RICE LIBRARY BUILDING COMMITTEE

Rice Public Library Monthly Report

Prime Contract Potential Change Order #009 : Historic Shelving Relocation

Prime Contract Potential Change Order #014 : ASI #2 Community Room Ceiling Changes

EXISTING SHELVING RECONFIGURATION

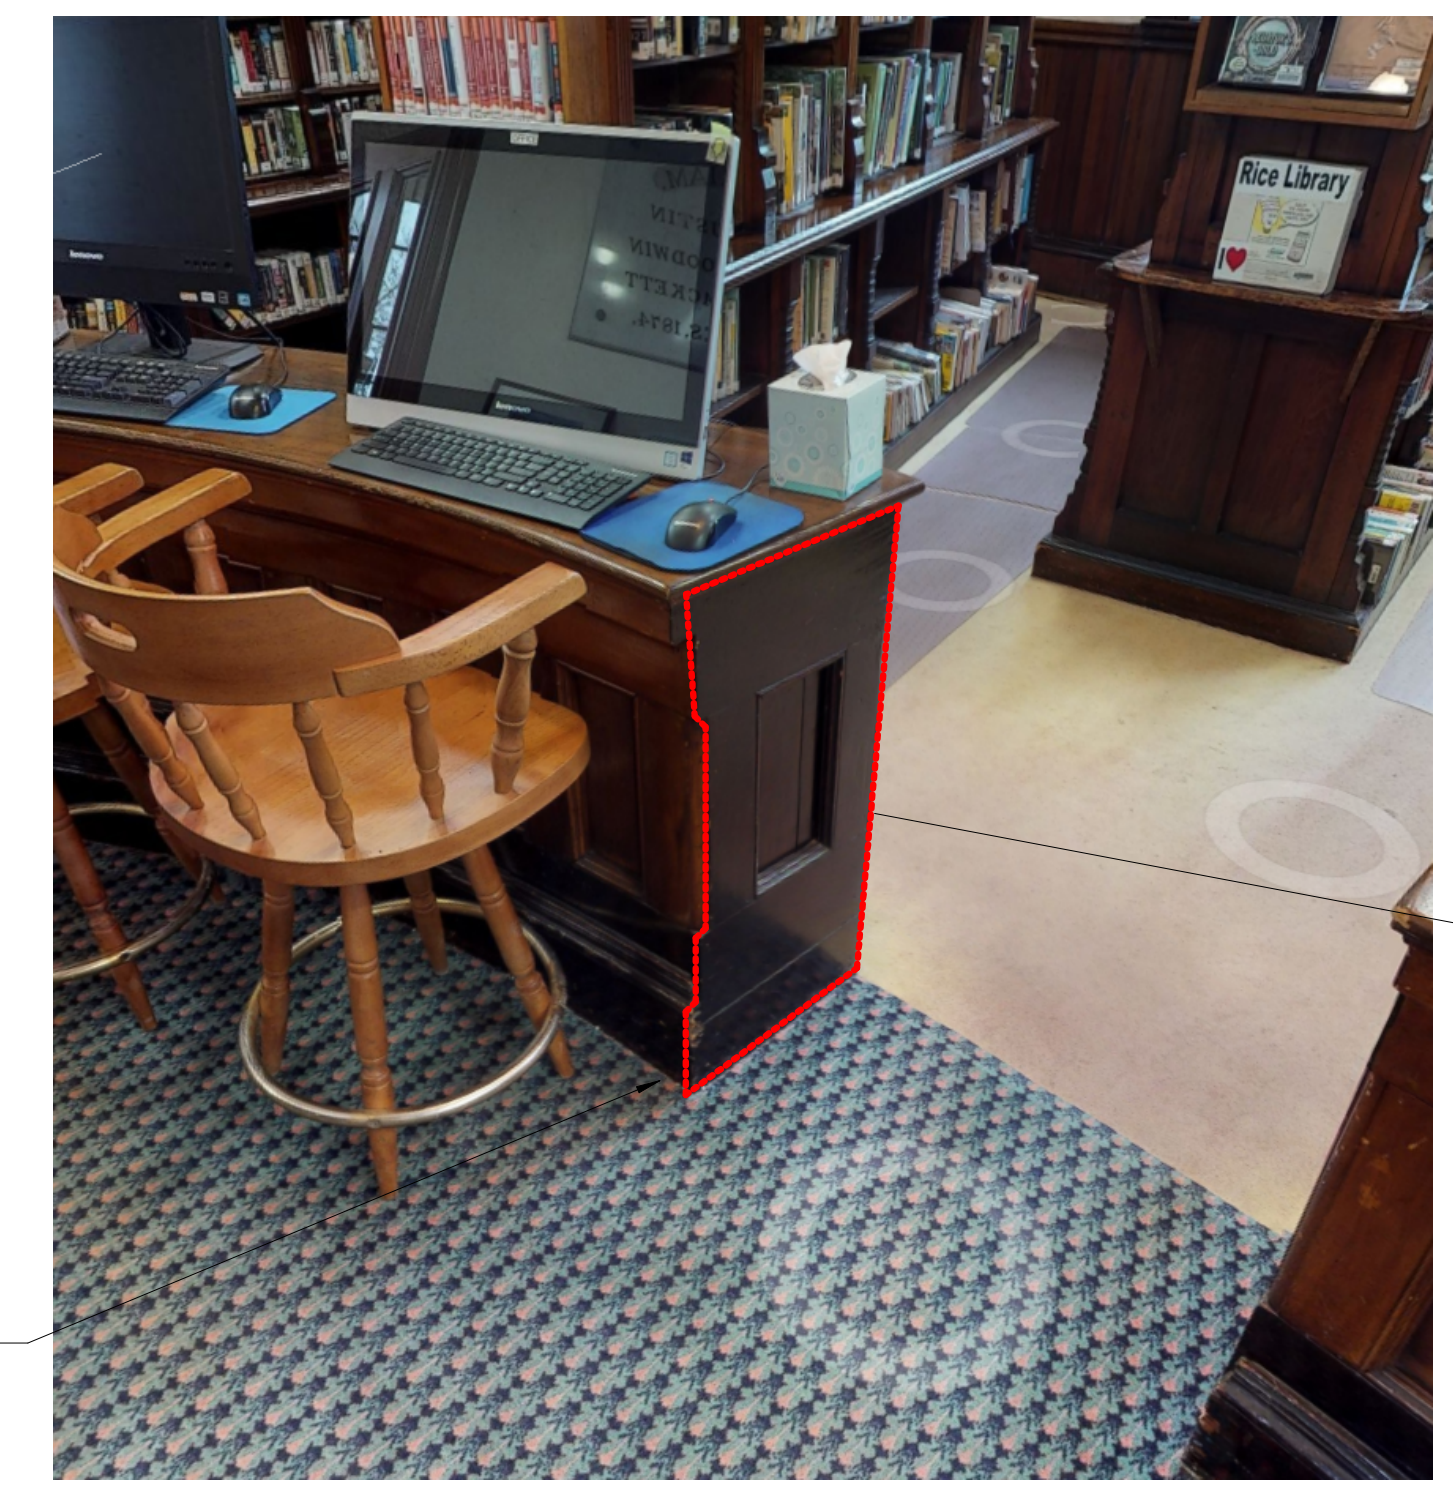
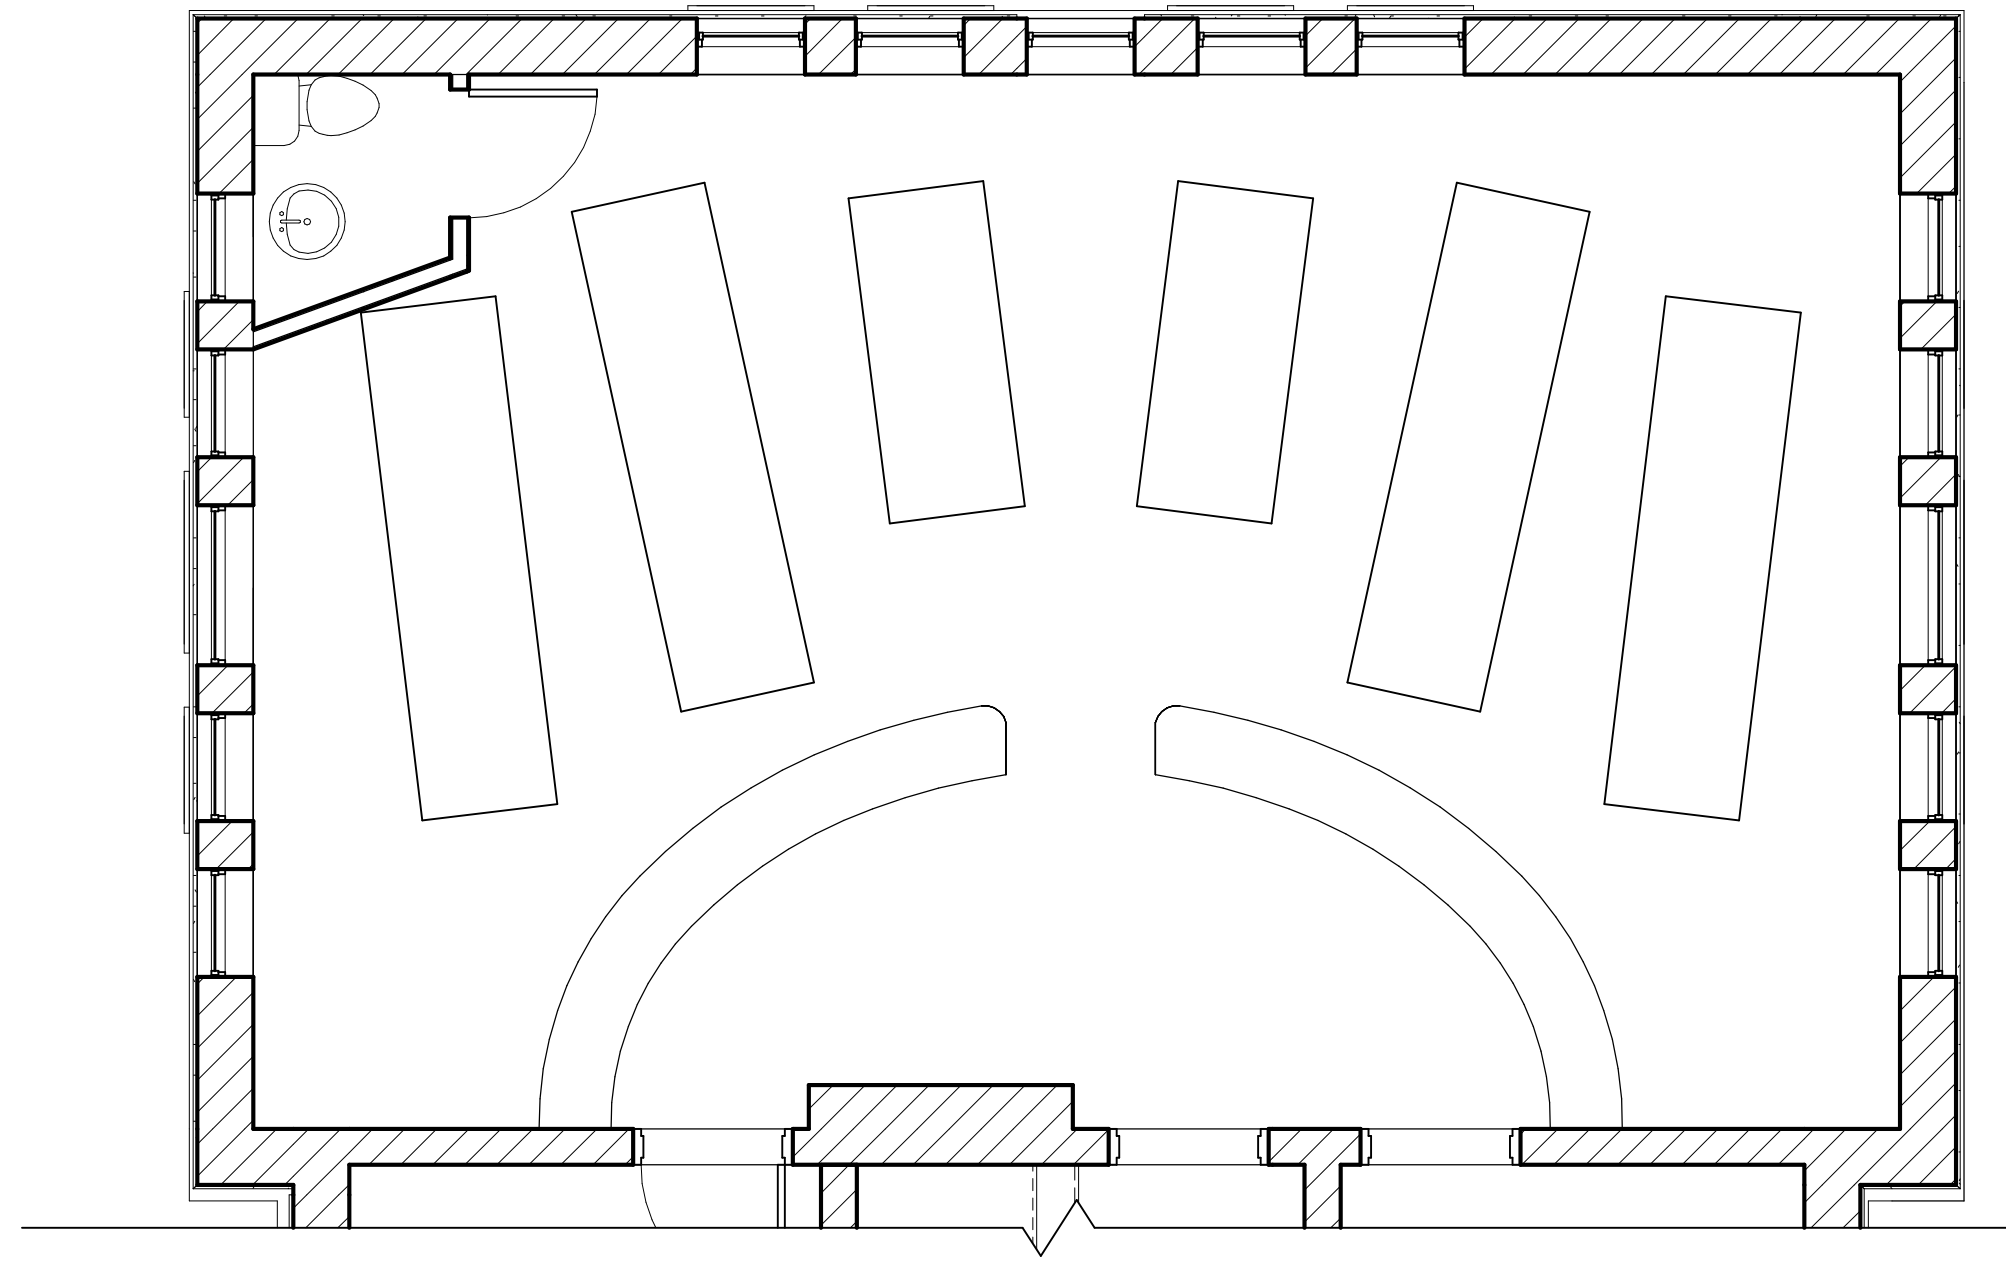
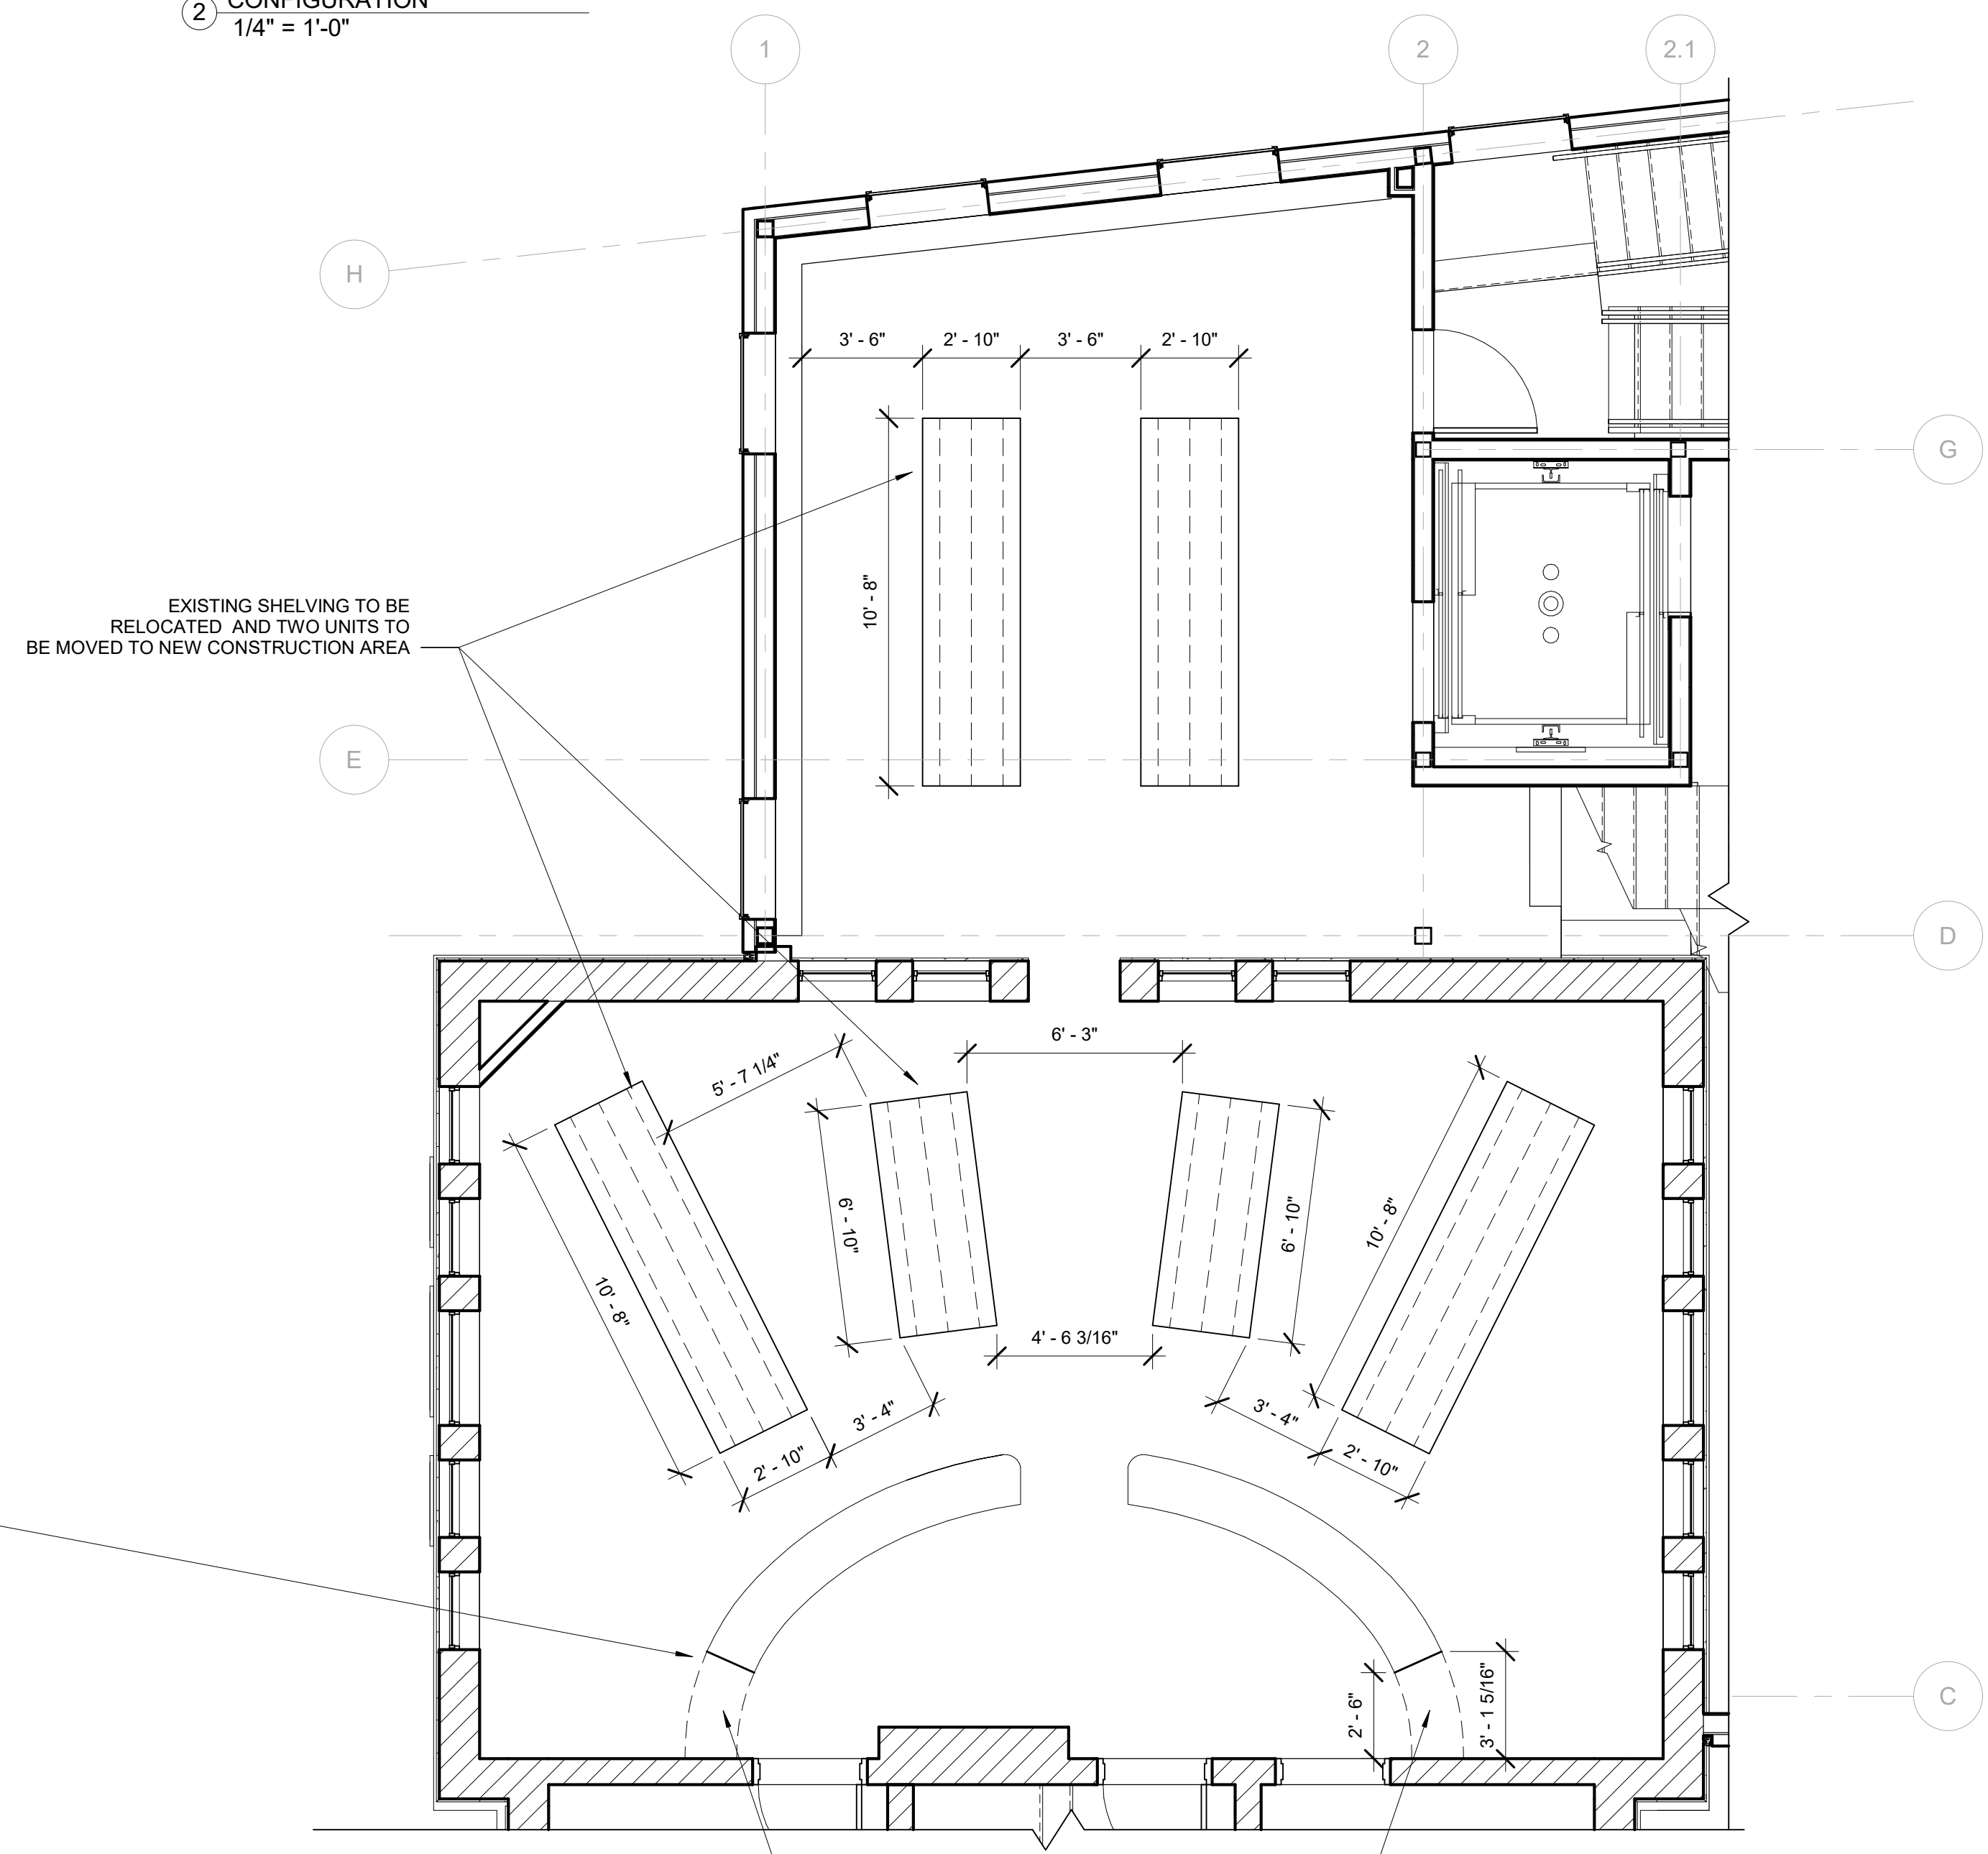
The following is a PCO from Pond Cove Millwork to preform on the Historic Shelving Relocation in the E Commons Room per the request from Matt Maiello at Scott Simmons Architects dated 3/15/2021.(See Attached). Please note that we carried \$1500 allowance for refinishing. This scope needs to be further defined once the will millwork is re worked.

EXISTING SHELVES TO BE SHORTENED BY 24"

REMOVE BOTH ENDS OF EXISTING HISTORIC COUNTER

WALL TO BE REPAIRED TO MATCH HISTORIC WAINSCOTING

REMOVE ALL SHELVING BELOW COUNTER

CUT-OFF ENDS OF COUNTER TO HAVE NEW END CAPS FABRICATED TO MATCH HISTORIC IN FINISH AND CONFIGURATION

ENDS OF EXISTING HISTORIC DESK TOPS AND BASES TO BE CUT BACK AND END PANELS TO MATCH CENTER WALKWAY INSTALLED
